ARCHITECTURAL REVIEW BOARD STAFF REPORT

Project #/Name	CCP-2019-02: Regional P25 Radio Infrastructure Project
Review Type	Advisory Review
Parcel Identification	076000000054P0, -54P1, - 54N1, and -54Z0
Location	County Office Building, 5 th Street (COB5) – 1600 5 th Street (Figure 1)
Zoned	Commercial Office (CO)/Entrance Corridor (EC)
Owner/Applicant	County of Albemarle/Harris Corporation (Helen Moeller)
Magisterial District	Scottsville
Proposal	Establish a microwave radio communications facility supporting operations of the Charlottesville-UVA-Albemarle County Emergency Communications Center (ECC) at its COB5 backup dispatch and equipment facility. See “Project Details” and Attachment A for additional information.
Context	The subject parcel lies on the south side of 5 th Street. Stagecoach Road is nearby on the east, south and west. Single family residences are on both sides of Stagecoach Road. Residential apartment complexes and Region Ten offices are located on the opposite side of 5 th Street. A mix of residential types are in the general area. (Figure 1)

Figure 2: Illustration showing the proposed monopole and dish antennas.

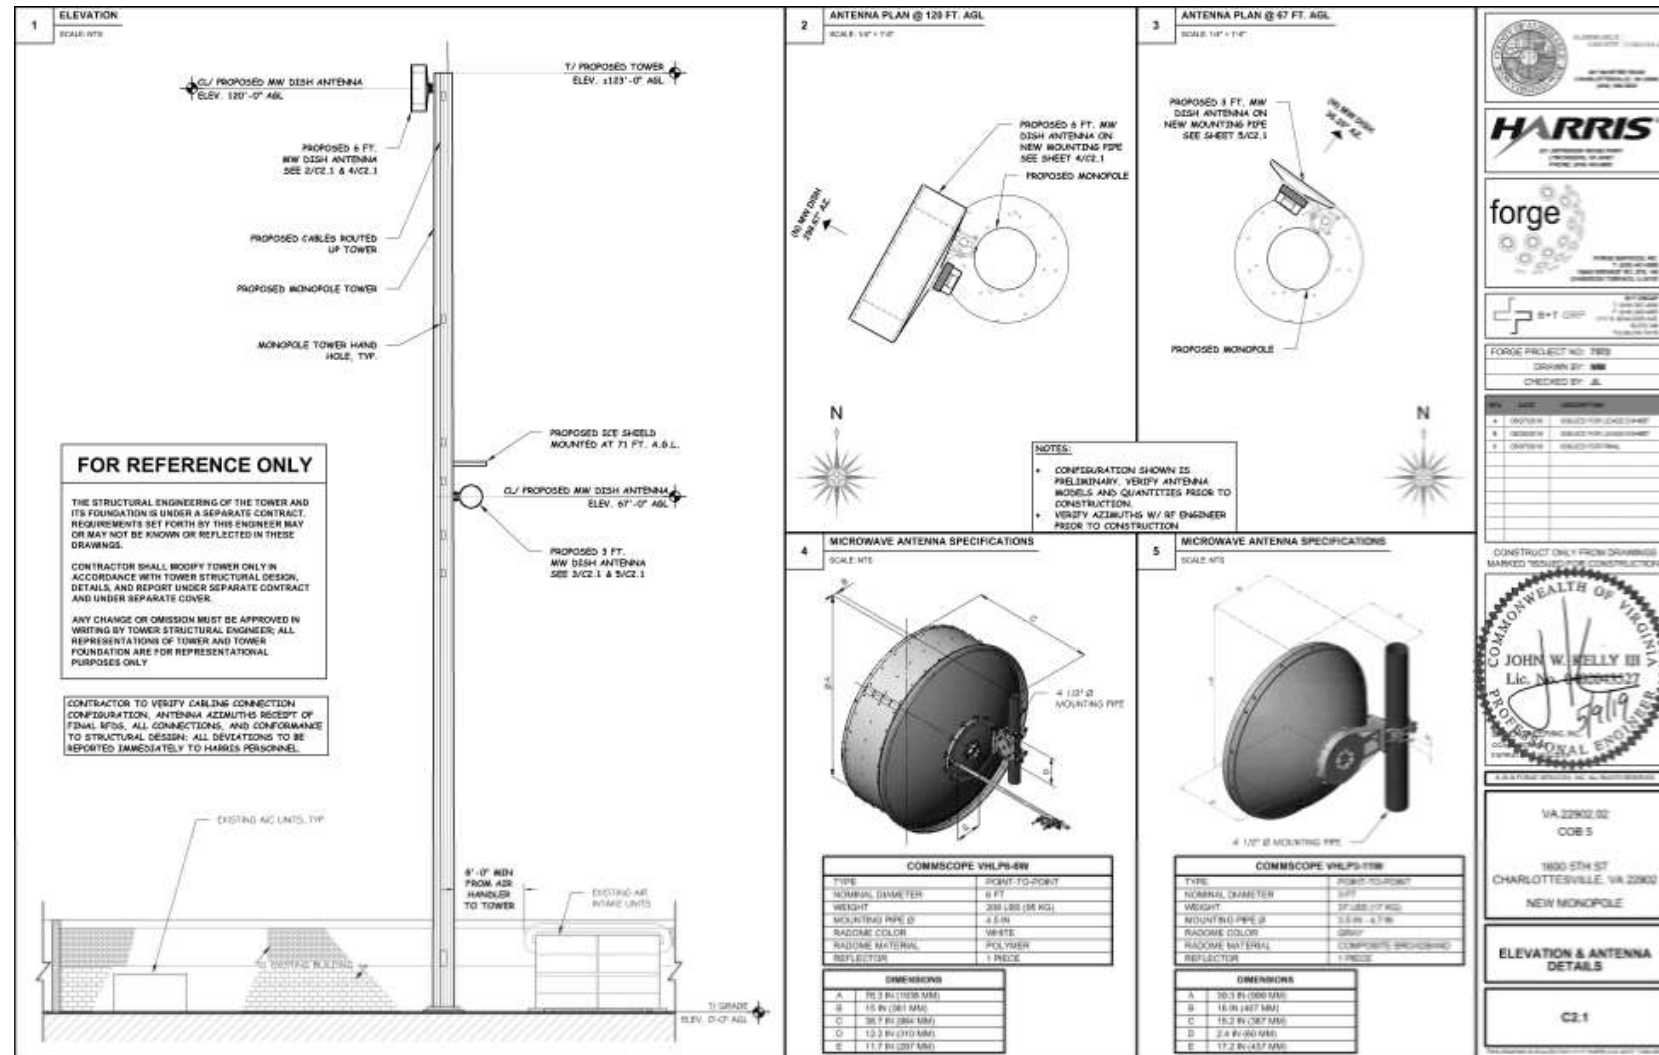
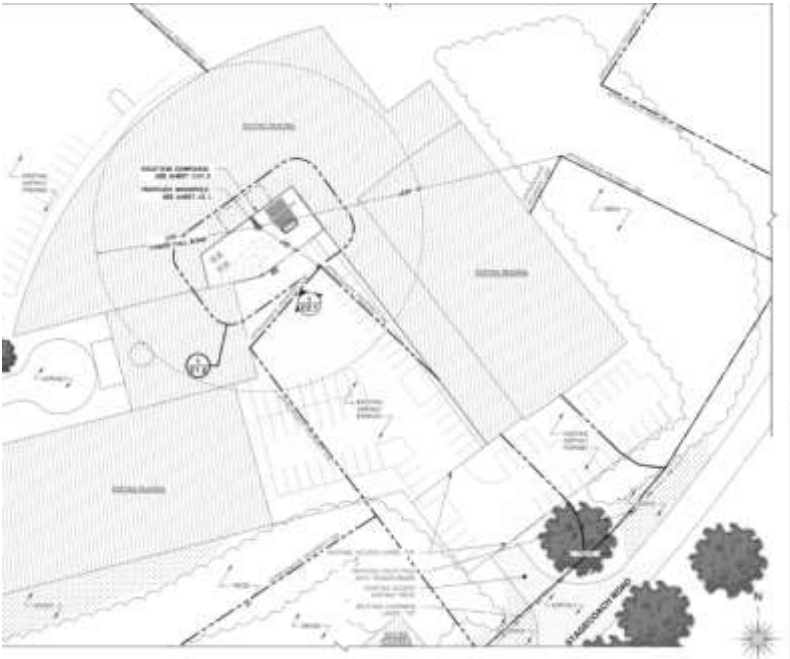
Ref	Guideline	Issues	Recommendations
	Accessory structures and equipment		
17	The following should be screened to eliminate visibility from the Entrance Corridor street: e) Mechanical equipment.	The ground equipment is not expected to be visible from the 5 th Street Entrance Corridor because the office building will provide full screening. (Figure 3)	No objection.

Since the ground equipment will not be visible from the EC, the ARB has no objection to the ground equipment and base station as proposed.
